MILPITAS PLANNING COMMISSION AGENDA REPORT

TITLE: "S" ZONE AMENDMENT NO. P-SA2003-3

Proposal: Request for building and site improvements associated with converting a residence to a commercial building for medical use.

Location: 429 South Main Street (APN 086-10-022)

SITE PLAN

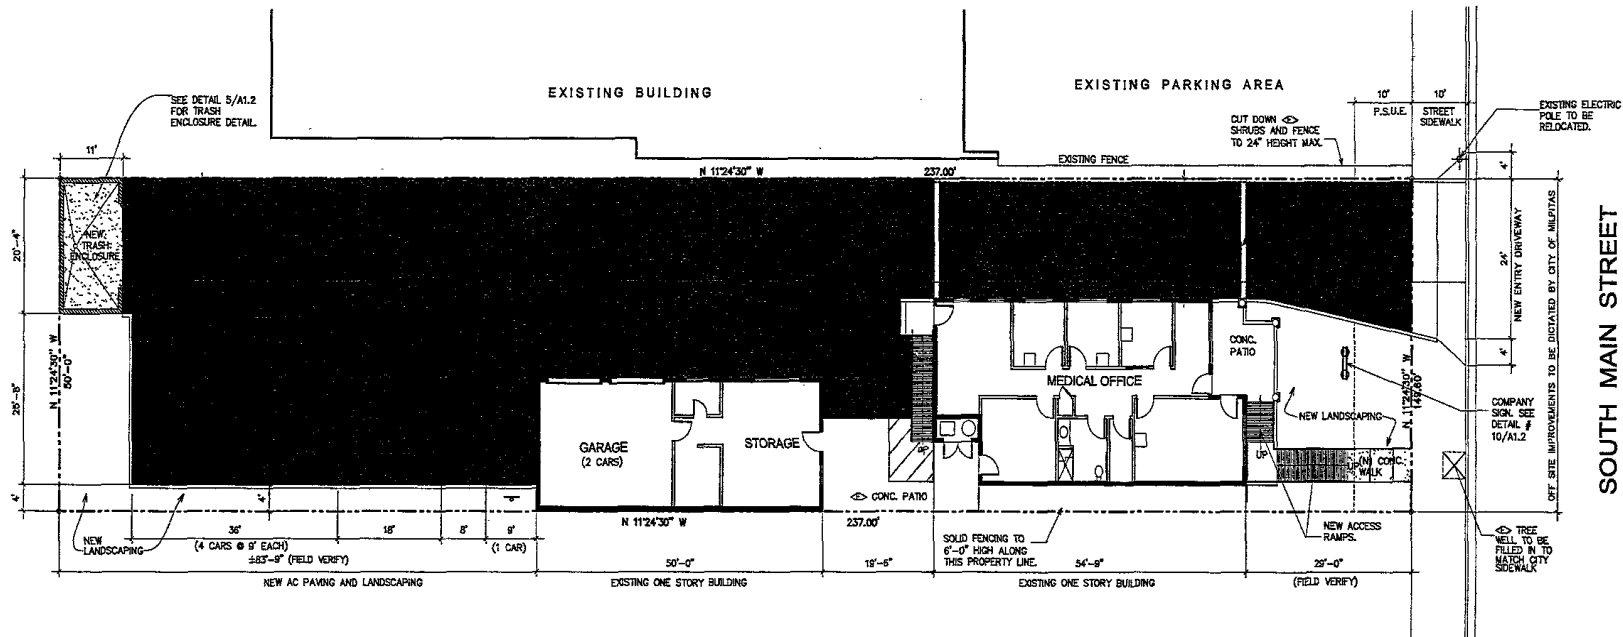
The only access to the site is from an existing 14-foot wide curb cut on South Main Street previously used to serve a gravel residential driveway. This curb cut is needed to provide vehicle access to the rear of the building and parking area. The change in use to a medical office with parking located in the rear requires the driveway to be upgraded since the existing residential driveway does not meet the width requirement for two-way commercial traffic, which is 20 feet, nor does it meet the driveway access width of 36 feet on this 50-foot wide lot. As recommended by the Engineering Division, the applicant proposes to widen the existing site access to 24 feet, with 4-foot wide flares on each side and pave the ± 18 foot wide driveway as the ingress and egress to the site. This redesign represents a significant improvement over the plan presented at the April 23, 2003 Planning Commission meeting. The suggested driveway width is still below the City standard of 36-feet wide, but this width of 24 feet would be sufficient for this site based on the 35 MPH speed limit on Main Street. This is because a vehicle moving at a slower speed can navigate the tighter turn of a narrower driveway and is less likely to cross over into opposing traffic. Unlike other commercial streets, Main Street is part of the Midtown Plan that includes Implementing Policy 4.16, which will introduce traffic calming measures, such as raised crosswalks, bulb-outs and other appropriate mechanisms that would also reduce the traffic speed on South Main Street in the future. Vehicle speed will be reduced on site by the construction of two speed bumps. As noted on Sheet A1.1, an electrical utility pole located on the sidewalk near

In addition to vehicular access, pedestrian access that is ADA compliant (4 feet width minimum) is also required from public right-of-ways and handicap parking areas. The project proposes two handicap access ramps at the front and rear entrances to the main building. An asphalt surface striped path for access from the handicap parking area to the rear entrance ramp is proposed, in addition to the ramp at the front of the property for handicap access from Main Street to the front entrance. This is a significant improvement over the design presented at the April 23, 2003 Planning Commission meeting.

- g) Show the proposed relocation of utility pole near the northeast corner of the site as a part of reconstruction of sidewalk and streetscape improvements. (P)

- C. Remove and relocate the existing utility pole to allow for the construction of new driveway. The new driveway shall be minimum of 24 feet wide with 4 feet flares on each side.

WEST ELEVATION
SCALE: 1/4" = 1'-0"

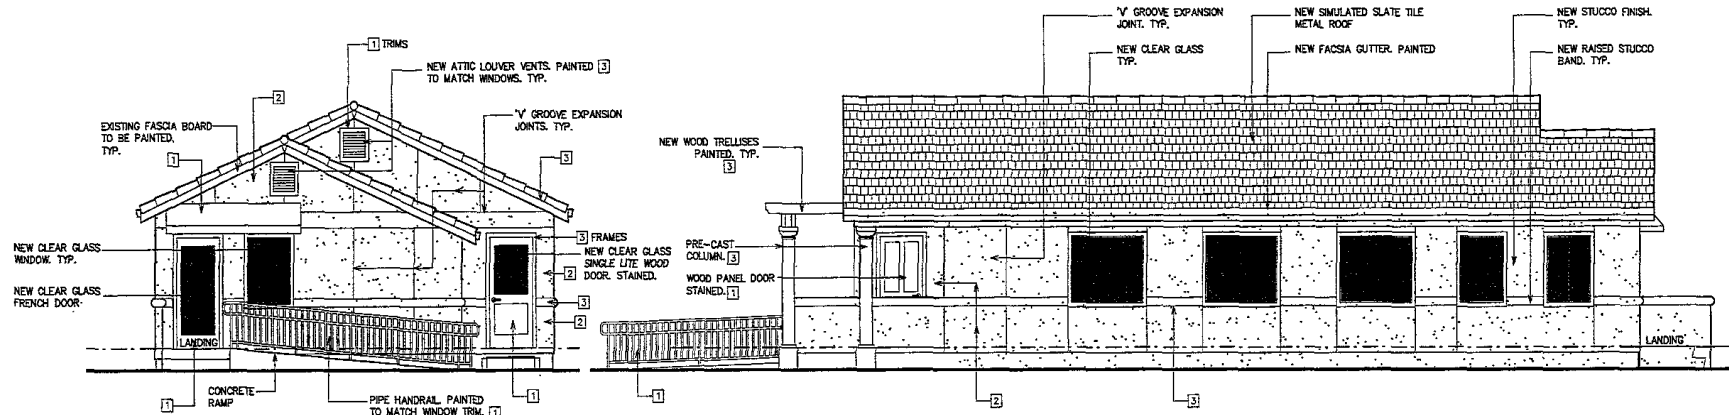
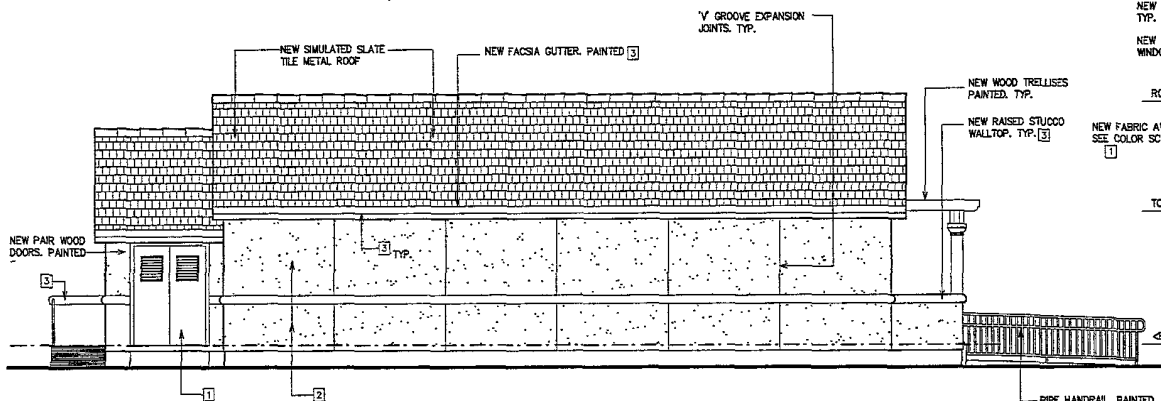
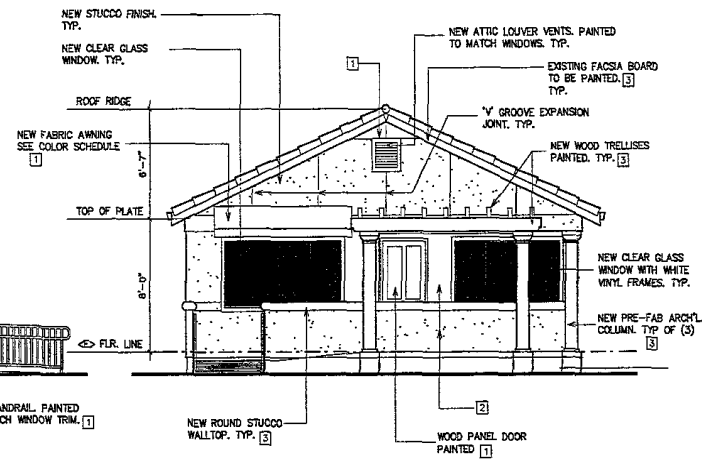
The exterior building modifications proposed are as follows (see Sheet A3.1 for details):

Staff suggests several changes to the above-mentioned architectural modifications that would assist in creating a more commercial feel to the existing residential structure and for consistency with the Design Guidelines of the Midtown Plan discussed later in this report. *Staff recommends* the plans be revised to address and include the following:

- a) Recess all windows;
- b) Modify pipe railing proposed at front and rear ramps to create a more openwork design or upgrade railing material;
- c) Show proposed locations of all exterior light fixtures; and

- d) Indicate locations, materials and colors of downspouts for roof drainage (show on plan if concealed in wall).

9. Prior to any building permit issuance, the applicant shall submit plans depicting the following architectural modifications:
- a) Recess or reveal all windows for consistency with the Midtown Design Guidelines Section B-3 (Fenestrations);

- b) Modify pipe railing proposed at front and rear ramps to create a more openwork design or upgrade rail material; and
 - c) Show proposed locations of all exterior building light fixtures (building fixtures in Lighthouse Wall Sconce in Chrome) and site lighting for parking and driveway areas (consistent with Midtown Design Guidelines Section C-5, a-e); and

- d) Locations, materials and colors of downspouts for roof drainage (show on plan if concealed in wall).
10. Prior to building permit issuance, the applicant shall submit an irrigation plan for all landscape areas.

LANDSCAPE PLAN

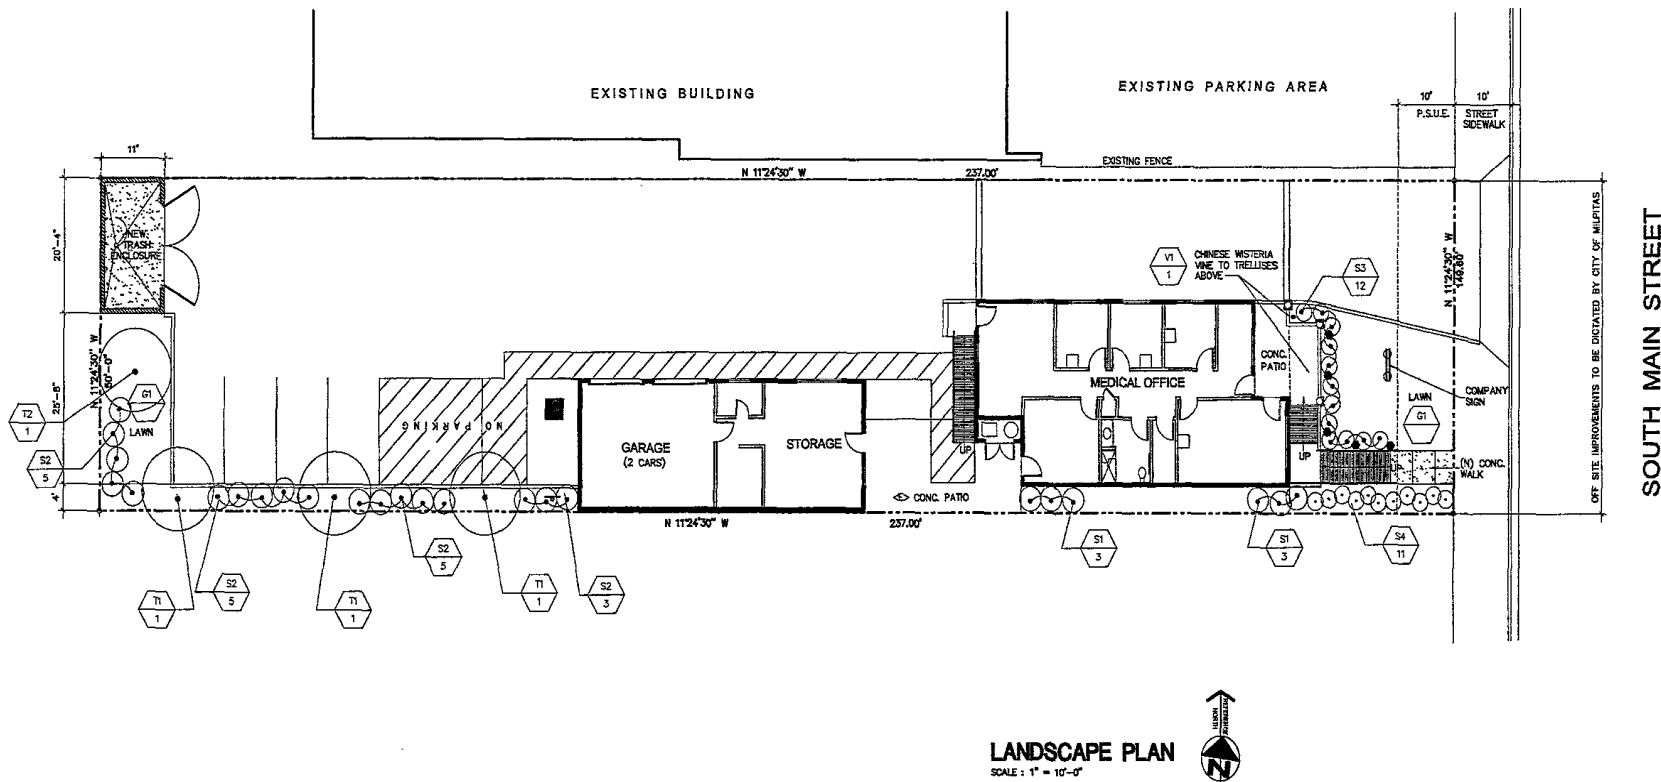
The applicant proposes to revise the existing landscaping in the front yard (includes removing brick and wood wheel and tree with a 20' diameter located in rear yard) and introduce new landscaping in the rear and side yards, as indicated on Sheet A4.1 of the project plans. The front yard would consist of a mixture of dwarf tobira and Indian hawthorn shrubs and dwarf fescue grass. Chinese Wisteria vines are proposed along the trellis. The southeastern area between the main building and southern property line would be planted with golden shrub daisies. The landscape areas along the southwestern and west property lines would contain the same groundcover as the front yard and variegated tobira shrubs, four (4) European white birch trees and one (1) Chinese hackberry tree. The applicant also proposes Pagoda Lights (model: P5204-38) in the landscape areas.

Similar to recommended architectural modifications, *staff recommends* the following modifications to the proposed landscape plan:

- a) Increase tree sizes to 24" box;
- b) Add at least one tree to front yard landscape area;
- c) To offset paving of most of the site, create a small landscape area, at least 70 square feet in size between rear of main building, rear accessory building and just south of striped access path with at least one (1) tree and similar shrubs proposed;

- d) In landscape area along south property line, between main building and proposed fence, add golden shrub daisies to area where no landscaping is proposed;

- f) Landscape areas abutting the public street, a 24-inch deep water barrier shall be installed behind the curb. Plans shall indicate curb elevation, which shall be approved by the Engineering Division prior to construction.

- g) Add locations of Pagoda lights in landscape areas.

4. Prior to building permit issuance, the applicant shall submit a revised landscape plan with the following:
 - a) Increase tree sizes to 24" box;
 - b) Add at least one tree to front yard landscape area;

- d) In landscape area along south property line, between main building and proposed fence, add golden shrub daisies to area where no landscaping is proposed;

- f) For landscape areas abutting the public street, a 24-inch deep water barrier shall be installed behind the curb. Plans shall indicate curb elevation which shall be approved by the Engineering Division prior to construction.

- g) Add number of and locations of Pagoda lights in landscape areas. (P).
- 5. Prior to any protected tree (36-inch circumference or larger) removal, the applicant shall obtain a tree removal permit from the Trees and Landscape section of Public Works Department at (408) 586-2601. (P)
